# CITY OF SAN ANTONIO

Re: **West Pointe Gardens**

MDP #003-06

WEST POINTE GARDENS SUBDIVISION  
 MASTER DEVELOPMENT PLAN  
 M.D.P. NO. 003-06  
 DATE: 4/6/2006

WEST POINTE GARDENS  
 MASTER DEVELOPMENT PLAN  
 M.D.P. NO. 003-06  
 DATE: 5/22/2006

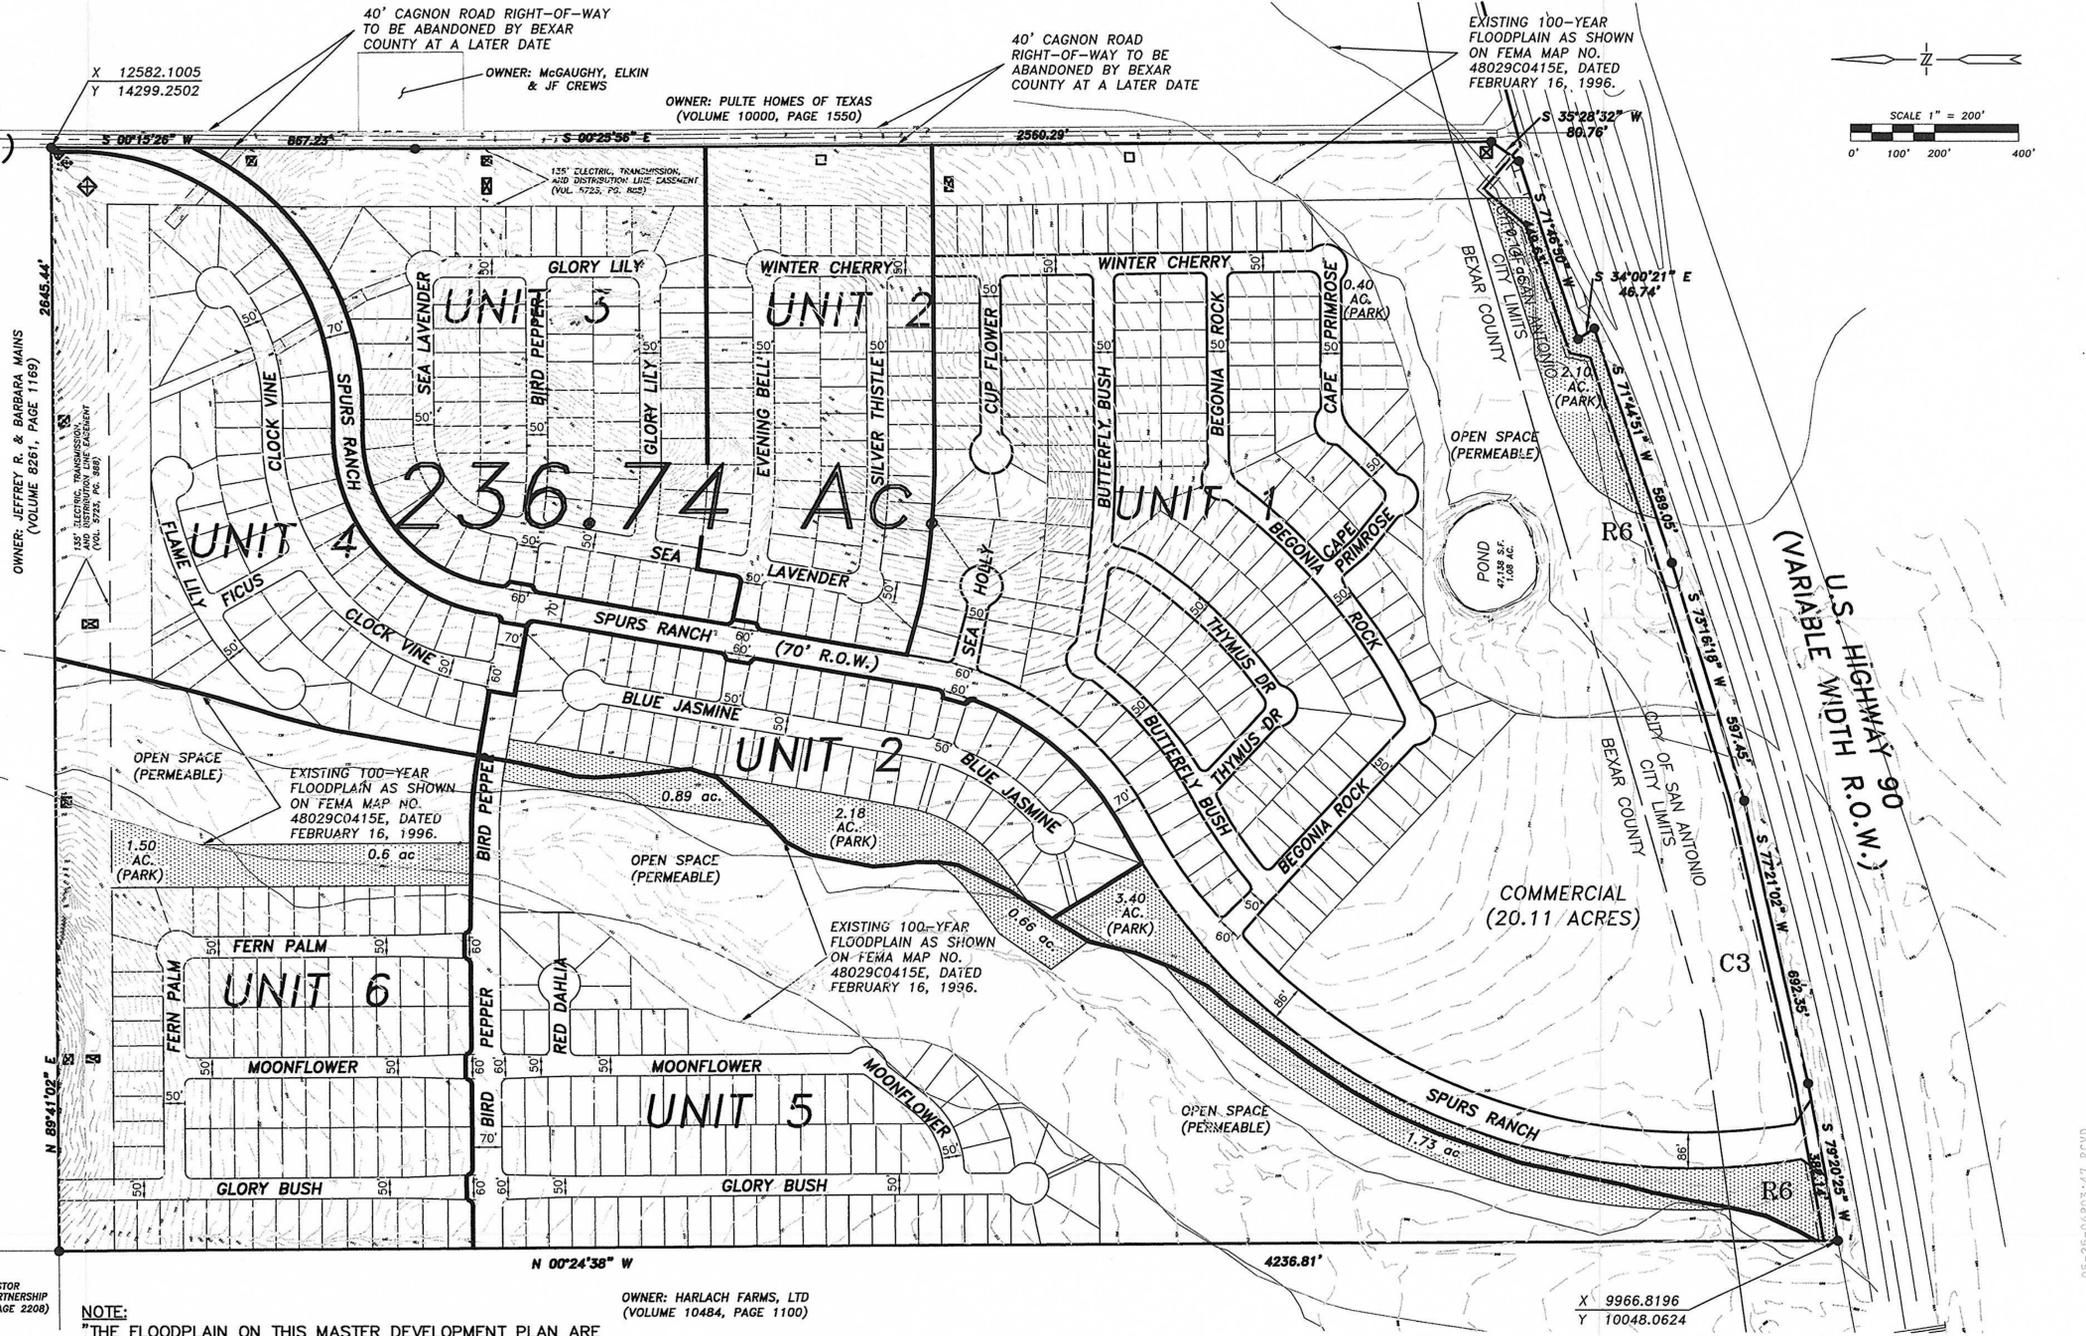
- In consideration of public safety and convenience, excessive grades by reason of topography should be avoided in street layouts and arrangements.
- Any access and R.O.W. issues along state facilities will need to be resolved with the **Texas Department of Transportation (TXDOT)**. For information about these requirements you can contact TXDOT at 615-5814.

- **Historic** has indicated the following conditions:
  - The Texas Sites Atlas indicates that archaeological site 41BX 774 has been previously identified within the above referenced property. Also, the property may contain other sites, some of which may be significant. Thus, before any work that might affect any sites is begun, we recommend that qualified professionals conduct an investigation of the property. The investigations should be performed according to Archeological Survey Standards for Texas, and previously identified sites should be reexamined and reevaluated, if any.

- All roadways shall follow Table 506-7, Functional Classification System Descriptions and shall comply with UDC 35-502(a)(9)
  - All access roadways shall provide clear sight distances on all existing and proposed roadways in order to provide adequate obstruction free viewing distances for approaching traffic. All signage, landscaping, and improvements shall be selected and located so as to not block these clear sight distance areas

- The developer shall be responsible for providing a right-turn deceleration lane, with storage length and bay taper per TxDOT design standards as it relates to the submitted TIA traffic counts, at the westbound frontage road of US 90 at the relocated Cagnon Road (Uniform Development Code (UDC) 35-502(a)(7), subsection C).

- Dedicated 86-feet of ROW and construct a 4-lane divided roadway (collector – relocated Cagnon Road). The Limits of construction shall be extended to the first intersection (Begonio Rock). Thereafter the developer shall dedicate and construct a 70-foot ROW and 4-lane undivided roadway (collector – relocated Cagnon Road) to connect into the collector in the Hillcrest Subdivision MDP.

- Dedicate 70-feet of ROW and construct a 4-lane undivided roadway (collector – Bird Pepper), from the proposed Cagnon Road to unplatted property to the west.

- All commercial driveways for this project shall comply with UDC 35-506(r) Access and Driveways.
- Sidewalks along all interior and exterior roadways are to be installed in accordance with UDC 35-506(q).

- **Trees** has indicated that this project will be subject to:
  - 2003 Tree Preservation ordinance standards per UDC Section 35-523
    - Residential Development – a Master Tree Permit has been issued for the residential units 1-6 of this MDP under A/P 1253549. Mitigation will be stated on plan.

- Commercial site requires a Tree Preservation Plan prior to any work on site. This can be submitted either as a site work permit, platting or building permit stage with additional permitting fees

- Streetscape standards per UDC Section 35-512 – The new ROW on Cagnon Road (collector) will require streetscaping. Plan and profiles will be required on plats with Cagnon Road.

- **Parks** recommends approval with the following conditions:
  - The parkland provided is dedicated to the Home Owners Association.
  - A provision and Maintenance Plan is provided to this department at the time of platting

- **Bexar County** remarks that:
  - The realignment of Cagnon Road will be built by a collector roadway section within the boundaries of this development

- Access to US 90 shall be mandated by the Texas Department of Transportation
  - Coordination with the adjacent Hillcrest Subdivision must be made for connection into Old Cagnon Road.
